Response to Highways England Deadline 7 Documents 8.80, 8.83, 8.84, 8.86 & 8.89:

8.80 Applicant's Comments on any Additional Information or Submissions Received by Deadline 6

Figure 7.1: DM 2021 and 2041 peak hour flows

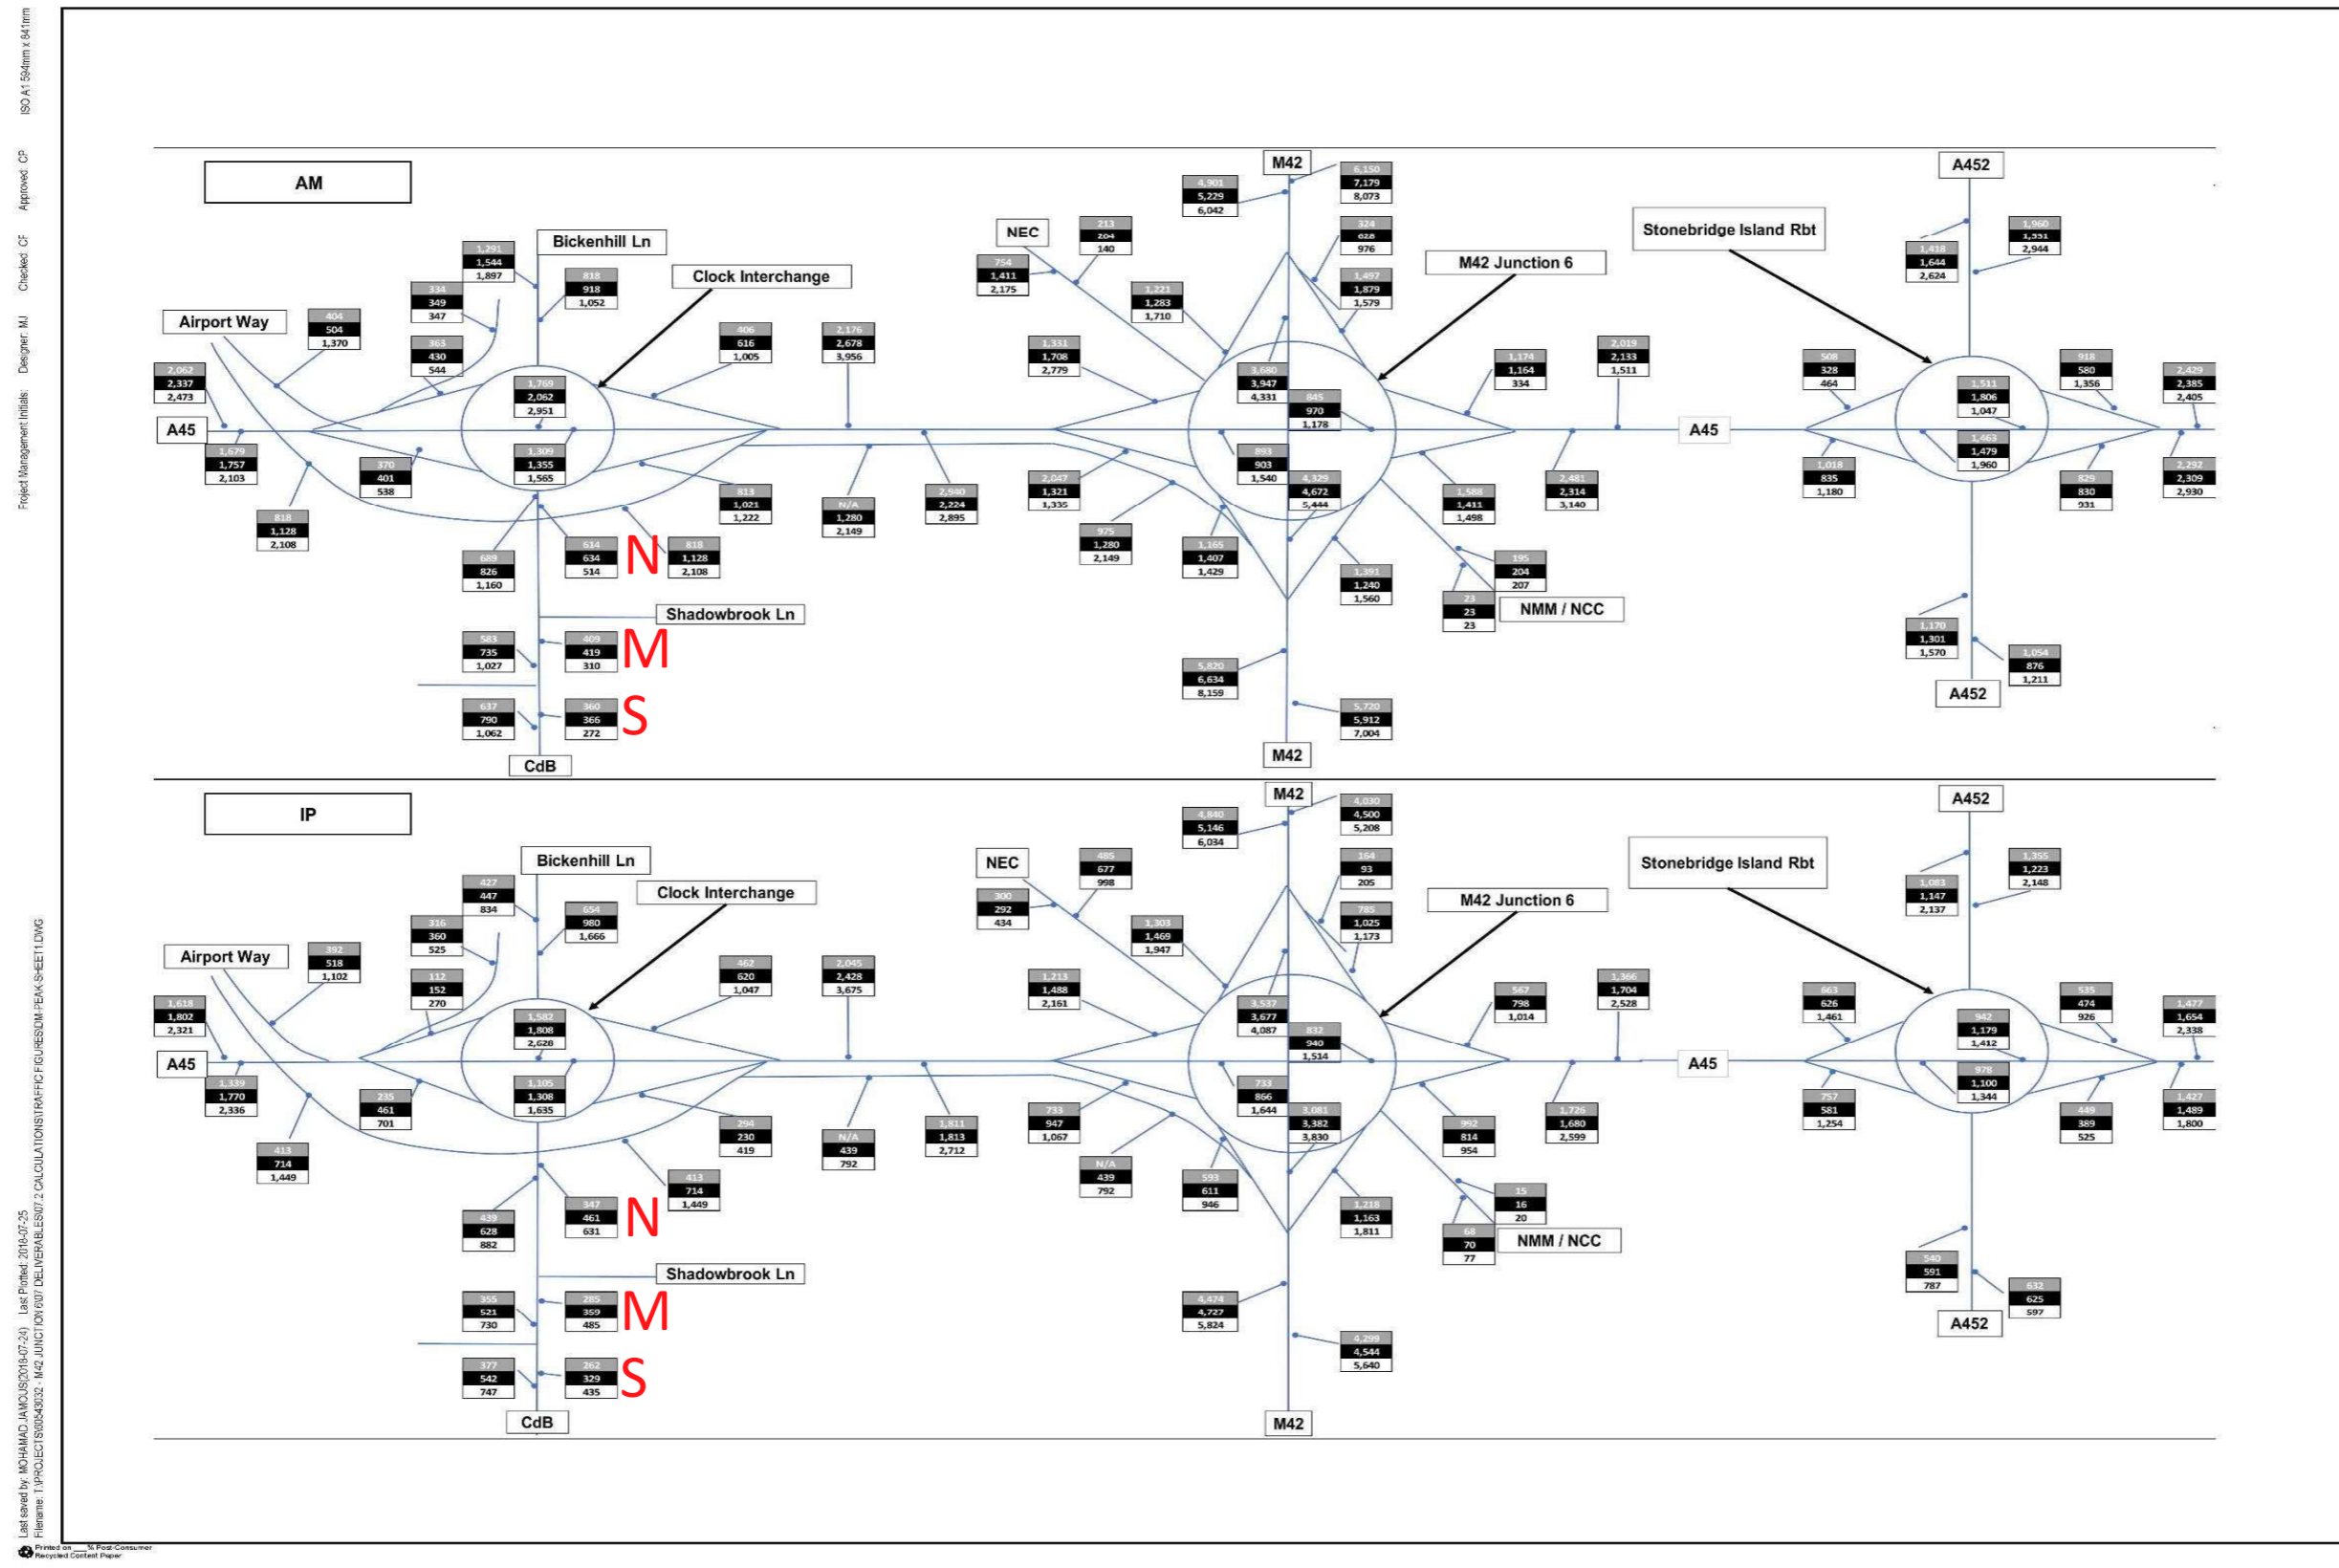
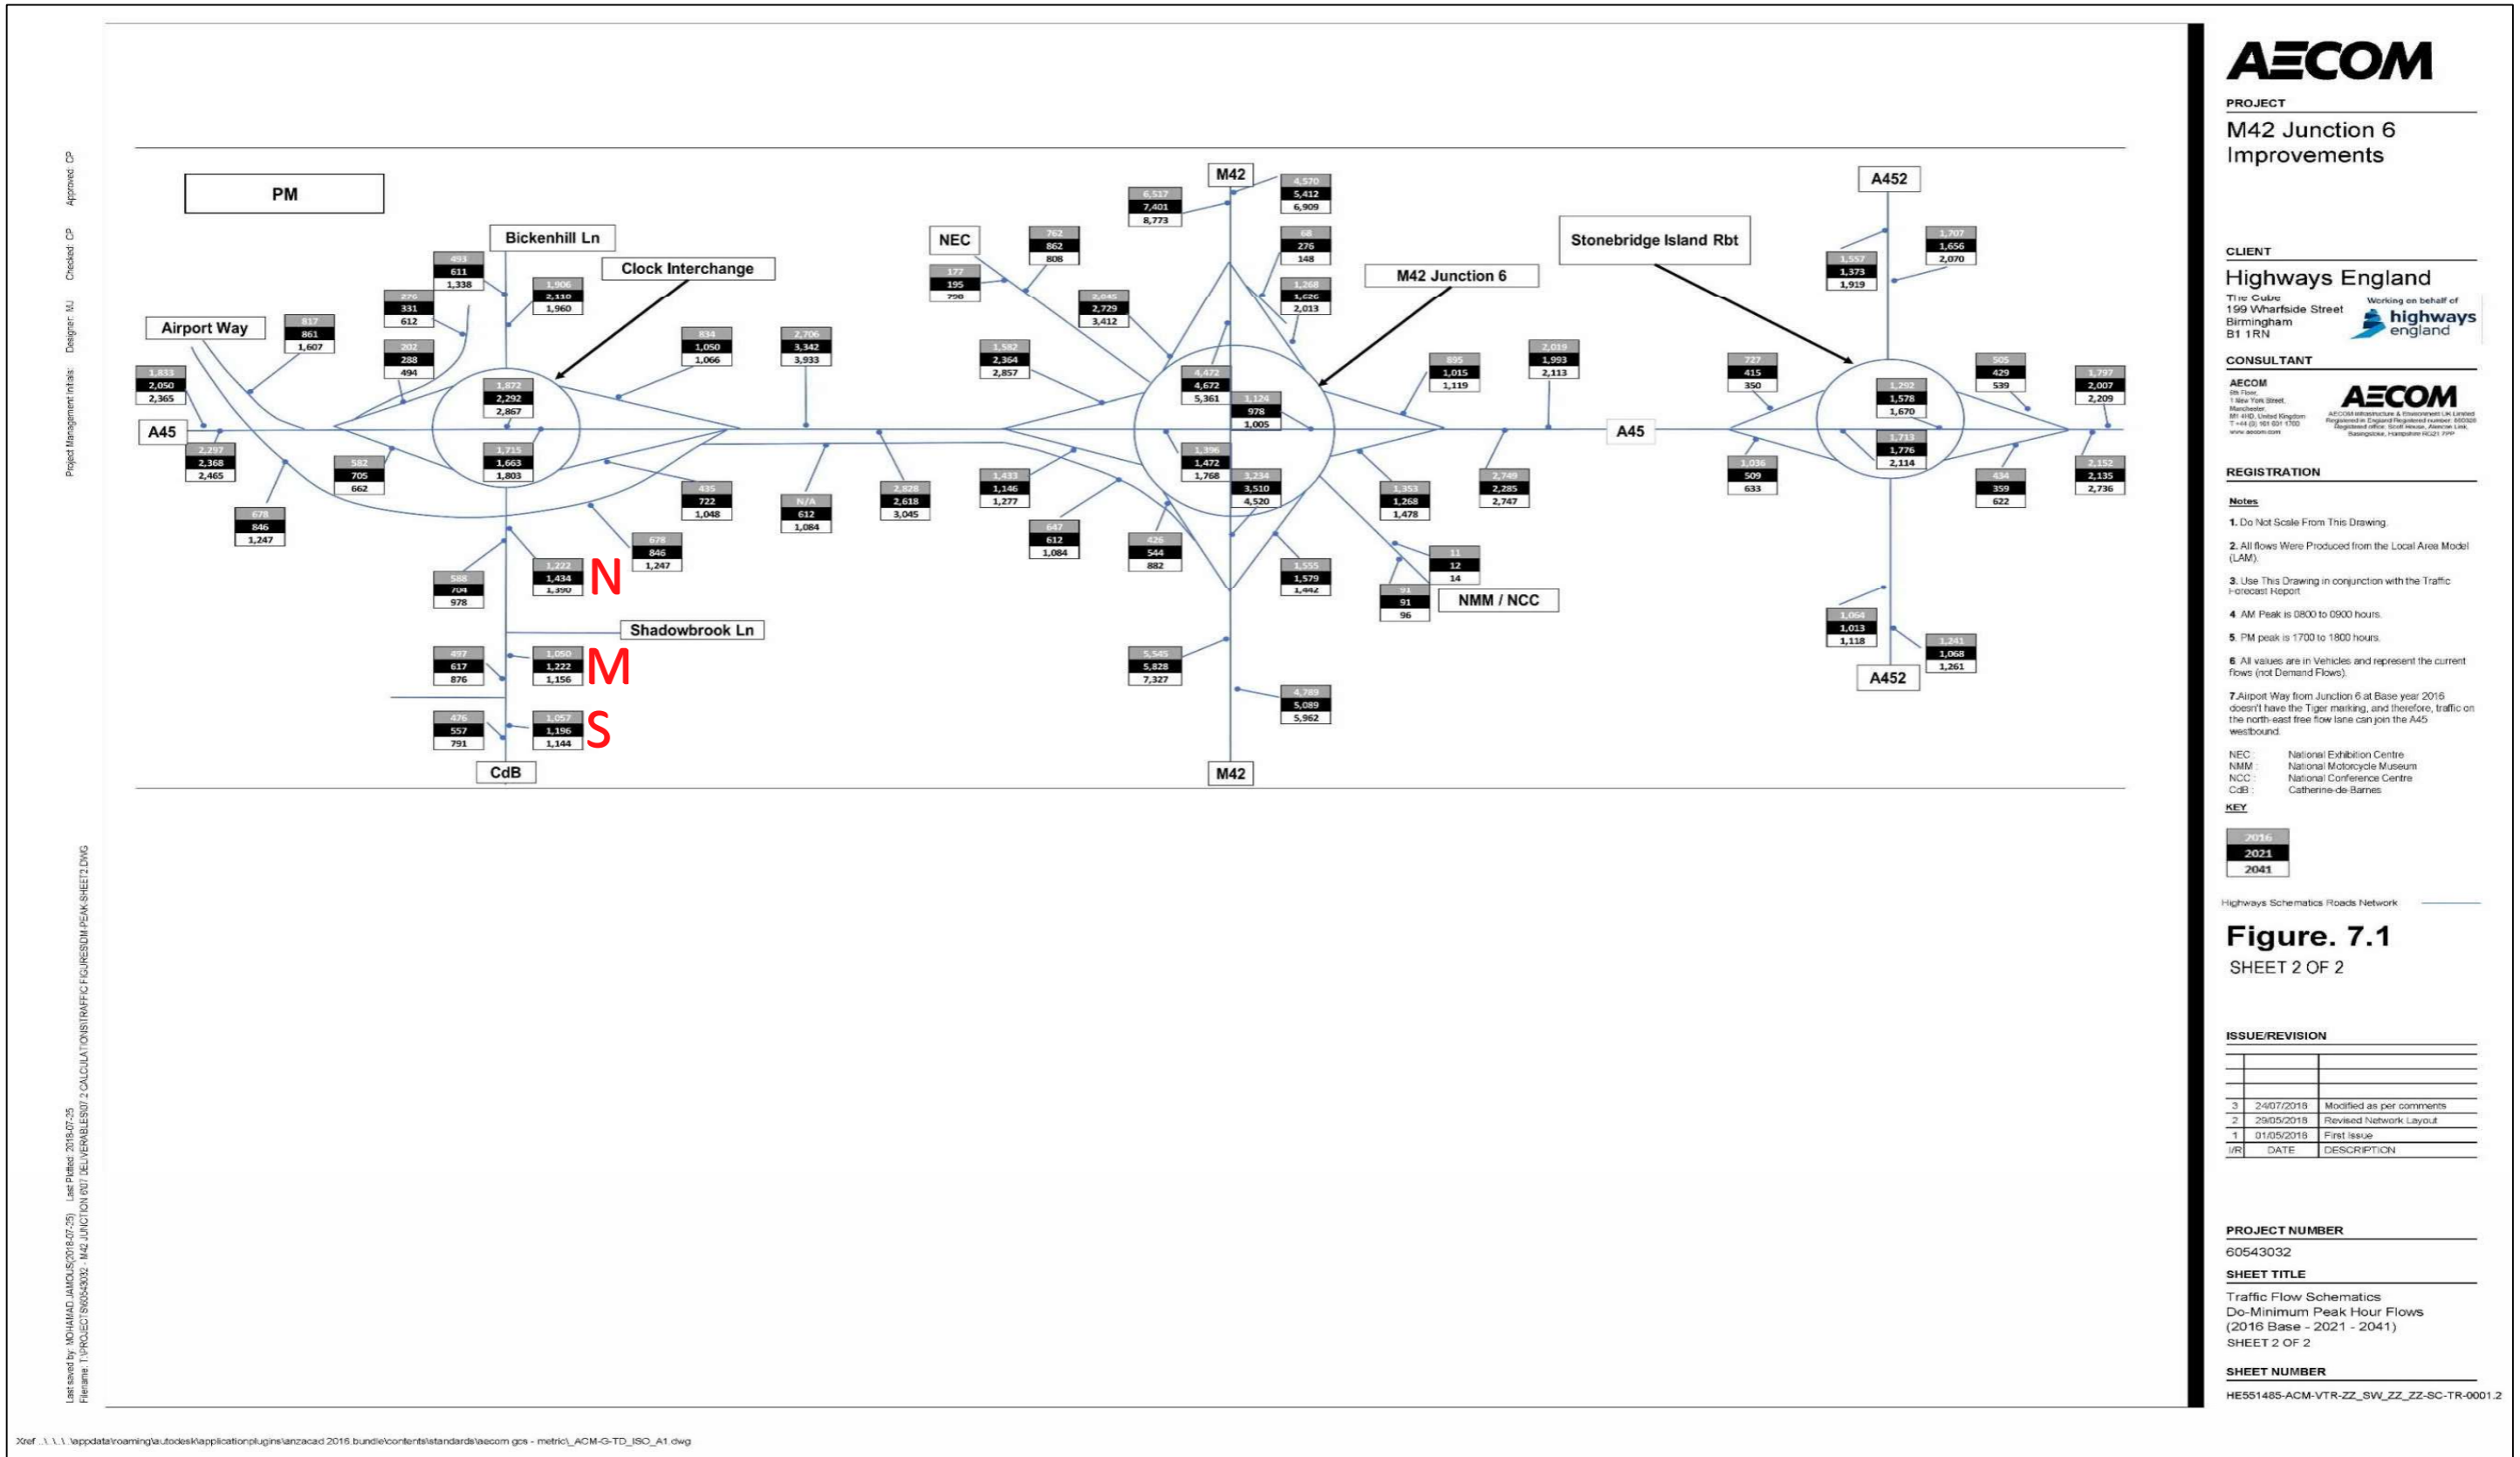
Figure 7.1 - Do-Minimum Peak Hour Flows (2016 Base – 2021 – 2041)

- All other roads on the diagram show an increase in Traffic Flow in year 2041 but Highways England are stating that Southbound Traffic Flow on Catherine de Barnes Lane will be lower during AM and PM hours, and higher during IP hours, in 2041 when compared to 2021
- Almost half the Traffic Flow in AM hours is going missing on the journey from the north end of Catherine de Barnes Lane to the south end
- There appears to be a false assumption that a lot of traffic is / will be using Shadowbrook Lane
